Access Compliance Report

Public Rights-of-Way

Intersection ID: 10030304	Main Street: LEES_COURT_ST	Cross Street: N/A	Location: SW
ADA ID: 3F1FC1CC06A8	Ramp Type: PerpDiag	Initial Pass/Fail: Fail	Overall Compliance: No
			Severity Score: 33.75

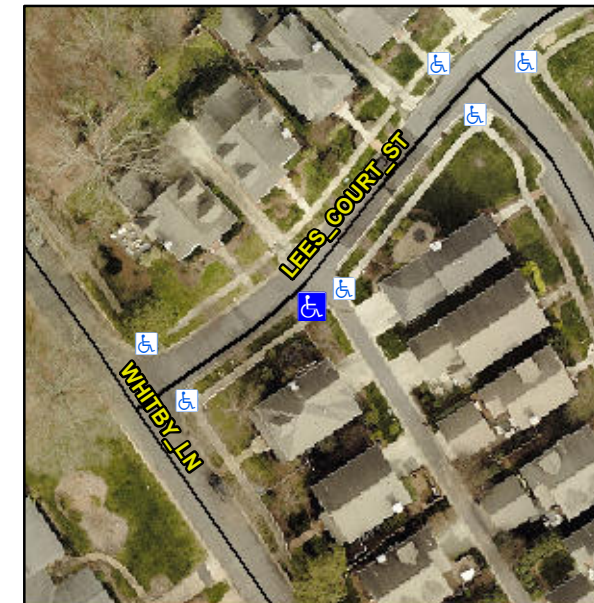
Not Found, R304.5.1, R304.2.2

Compliance	Description	Data	Compliance	Description	Data
N/A	Ramp Length (in)	65.0	No	Ramp Slope (%)	12.7
No	Ramp Width (in)	43.0	Yes	Ramp XSlope (%)	1.1
N/A	Flare Type LT	N/A	N/A	Flare Type RT	N/A
N/A	Flare Slope LT (%)	N/A	N/A	Flare Slope RT (%)	N/A
N/A	Flare Traversable LT?	N/A	N/A	Flare Traversable RT?	N/A
N/A	Landing Length (in)	N/A	N/A	DWS Provided?	N/A
N/A	Landing Width (in)	N/A	N/A	DWS Contrast?	N/A
N/A	Landing Slope (%)	N/A	N/A	DWS Length (in)	N/A
N/A	Landing X Slope (%)	N/A	N/A	DWS Full Width?	N/A
N/A	Landing Curb? (Y/N)	N/A	N/A	DWS Offset (in)	N/A
N/A	Shared Landing?	N/A			
N/A	Gutter Ponding?	N/A	N/A	Gutter Slope (%)	N/A
N/A	Gutter Lip Ht (in)	N/A	N/A	Gutter X Slope (%)	N/A
N/A	Painted X Walk1?	No	N/A	Painted X Walk2?	No
	X Walk 1 Direction	To NE		X Walk 2 Direction	To N
N/A	X Walk 1 Width (in)	N/A	N/A	X Walk 2 Width (in)	N/A
	X Walk 1 Slope (%)	3.9		X Walk 2 Slope (%)	1.0
	X Walk 1 X Slope (%)	0.2		X Walk 2 X Slope (%)	2.2

Remove & Replace Curb Ramp With Two New Directional Ramps or Equivalent.
